BOARD/COMMISSION: Nickel Plate Review Committee Meeting

DATE: 11/15/2023, at 5:00 PM

Nickel Plate Review Committee Staff Report

REQUEST: Request approval of the site plan and architecture for the expansion of Fishers Elementary School, which includes an addition and renovation of the existing structure. The subject site is located at the intersection of Lantern Rd. and Morgan Dr.

SITE REFERENCE
PLAN

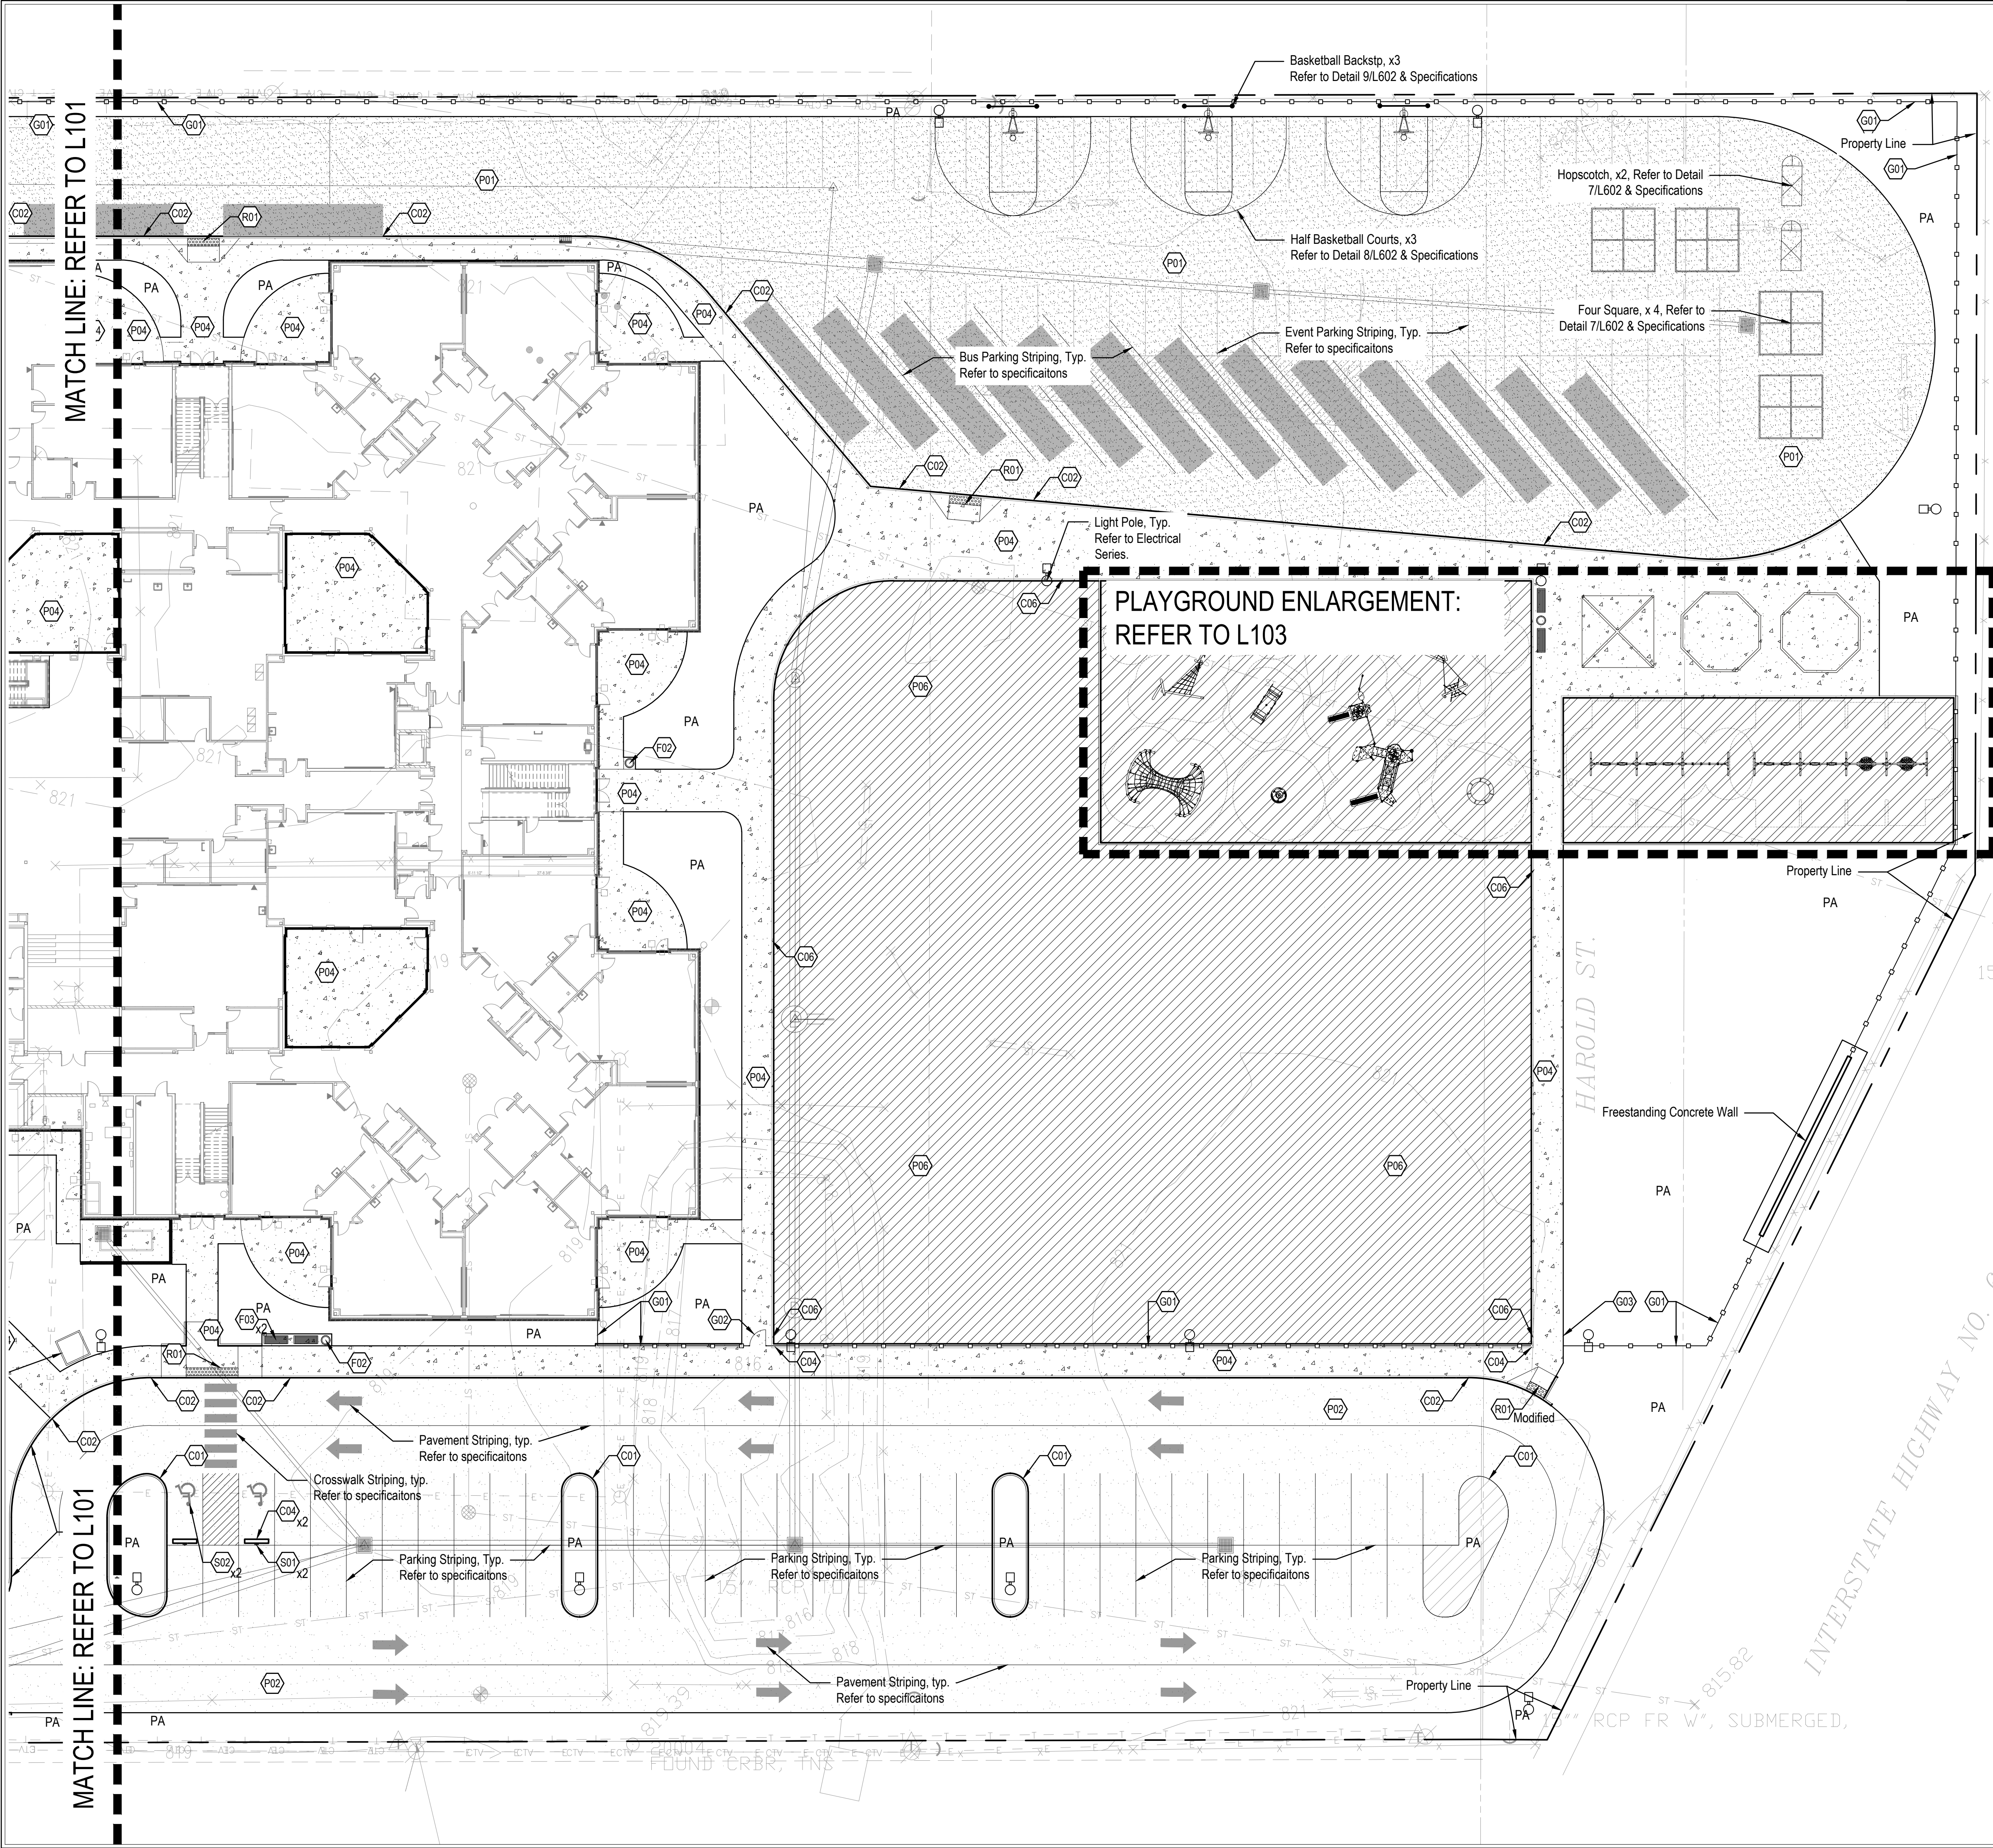
Pedestrian access is provided along Lantern Rd. Staff is requesting that the location of the sidewalk be pushed back from the street to provide a buffer to protect pedestrians from traffic.

✓ Parking and vehicle circulation: Parking will be located between Lantern Rd and the front façade of the school as well as along the Southern Property Line. A new bus lot will be created on the Northeastern portion of the property.

PLANTING
REFERENCE PLAN

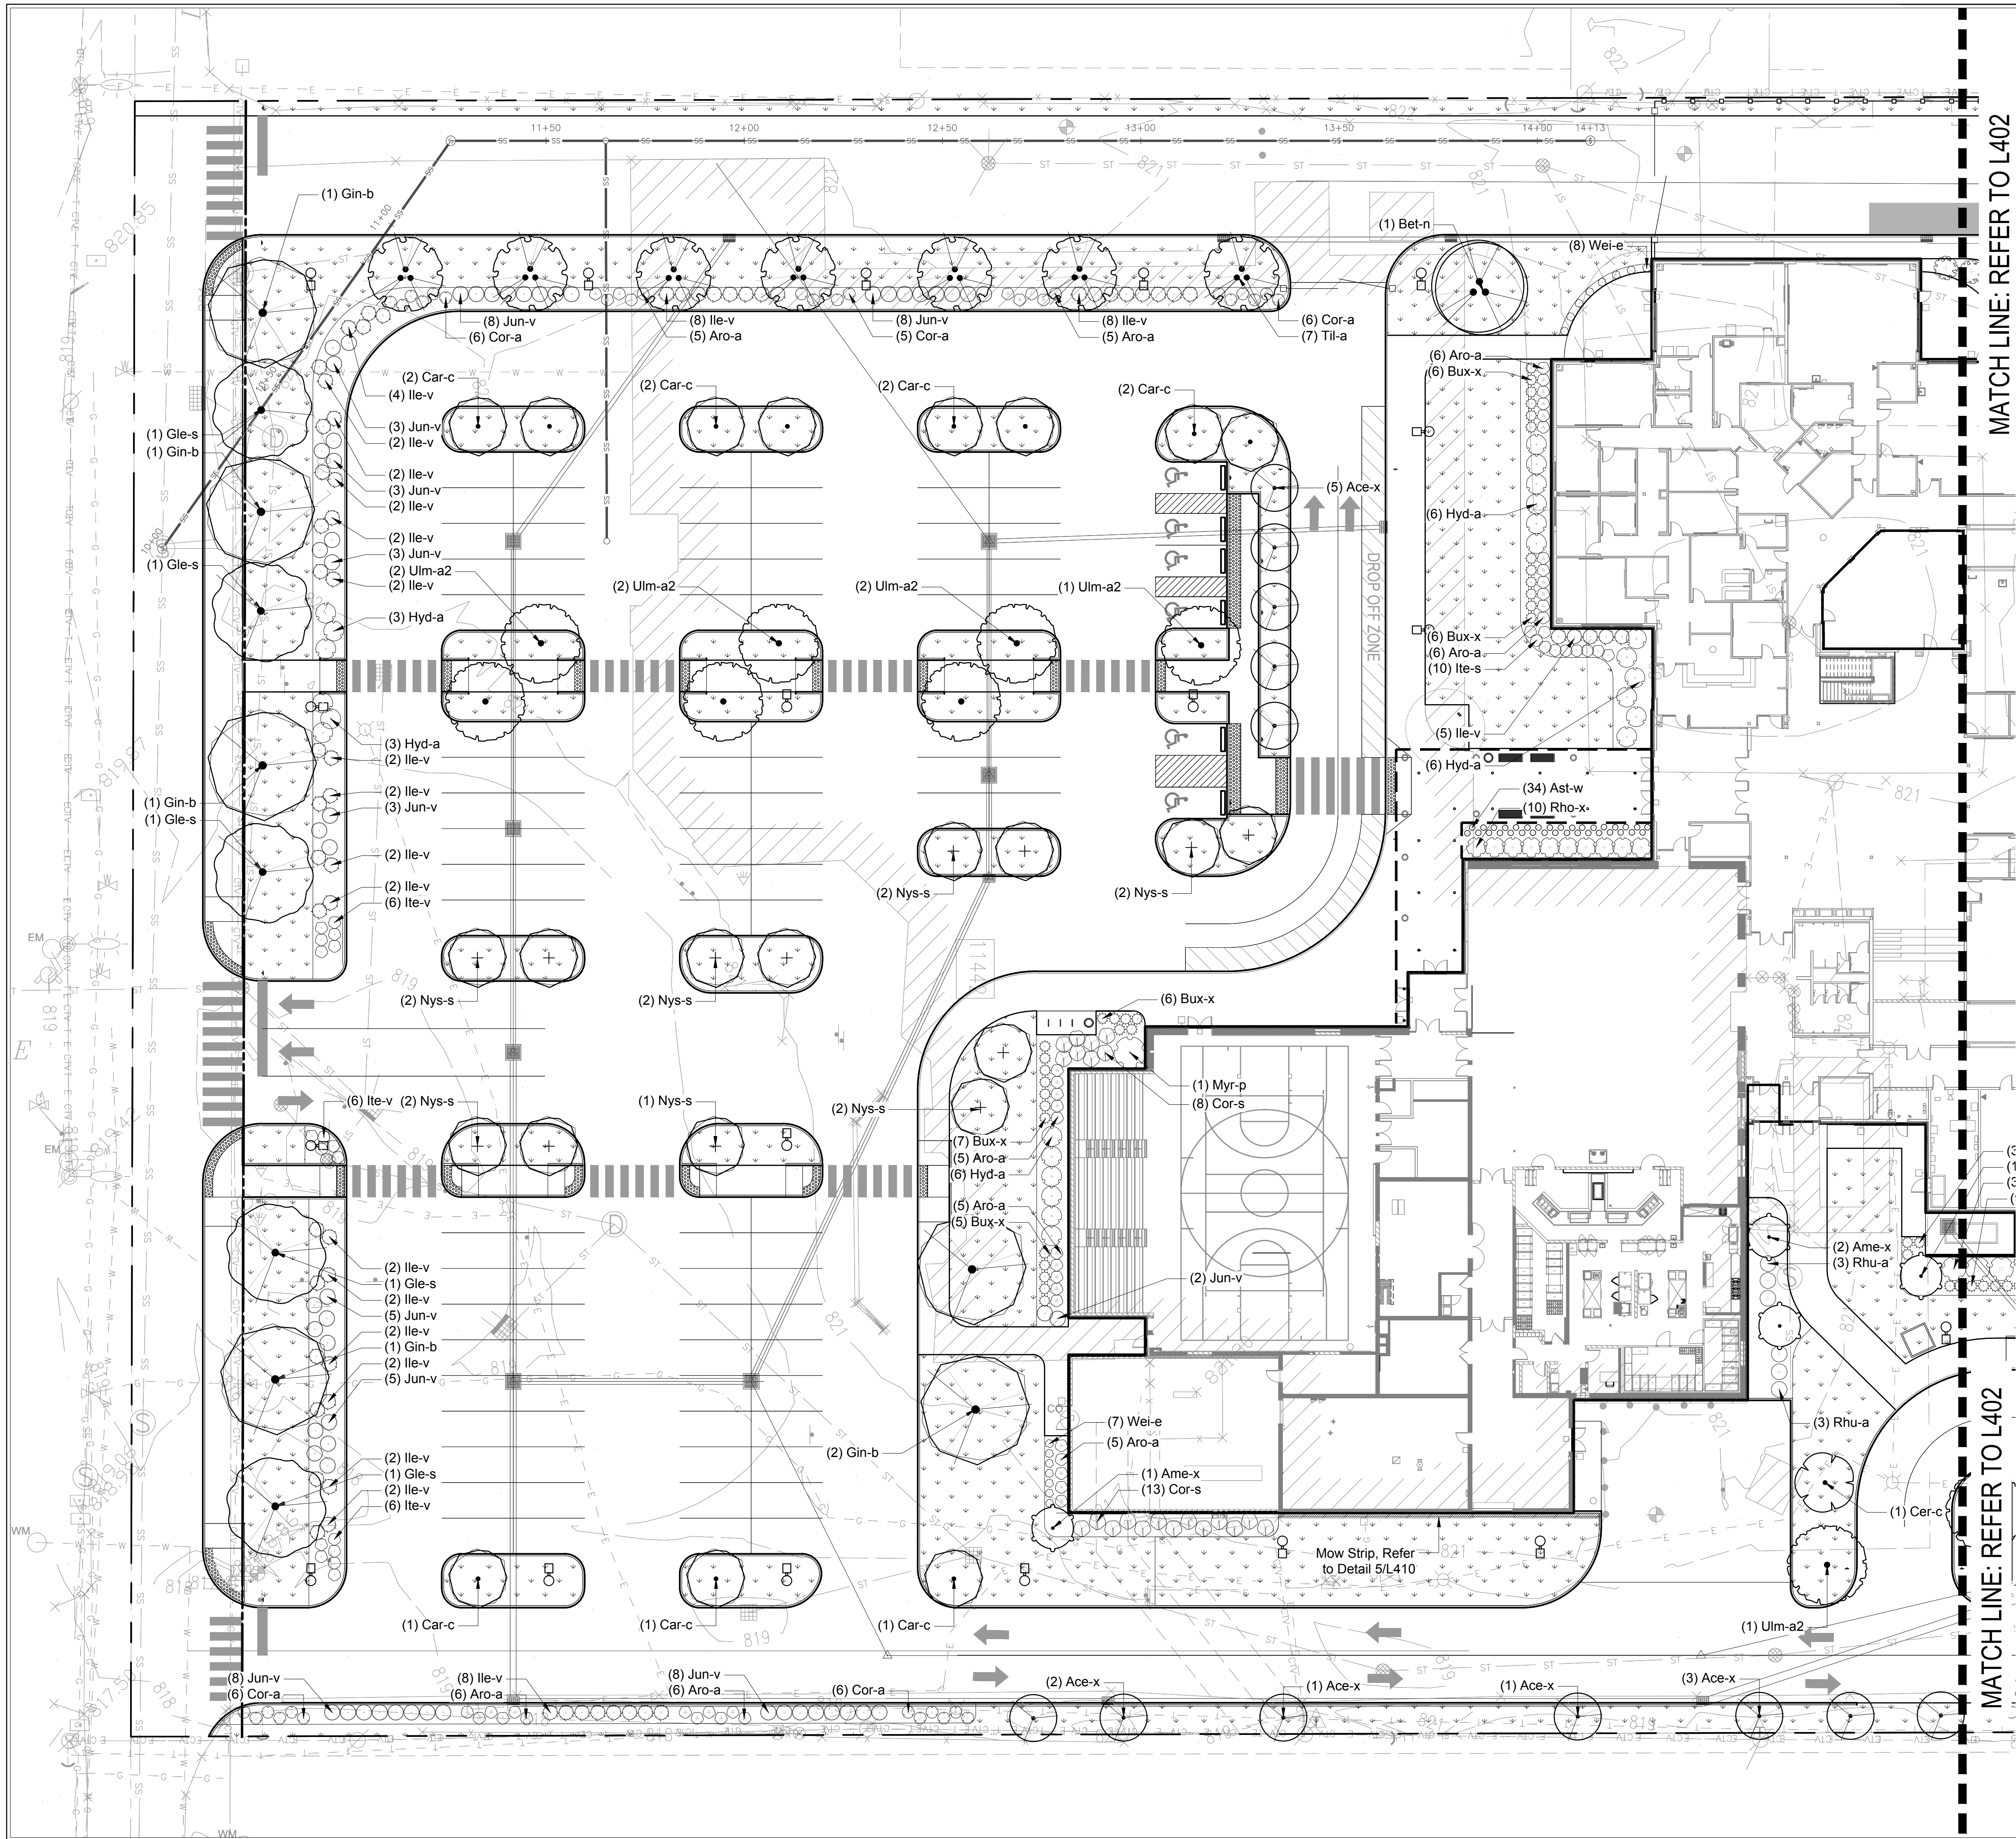
2. Maximum Side Setback – The Nickle Plate Code requires a maximum side setback of 15; in the Village Center. The proposed setback is requested to be approximately 40’.
3. Landscaping – The School is proposing less foundation landscaping than required for safety reasons. The petitioner is also requesting no parking lot landscaping in the bus parking lot to allow ample room for maneuvering.

Foundation Planting

Provided: (118) shrubs

Provided: (126) shrubs + (11) ornamental trees

Provided: (0) evergreen shrubs + (0) deciduous shrubs

Provided: (46) trees
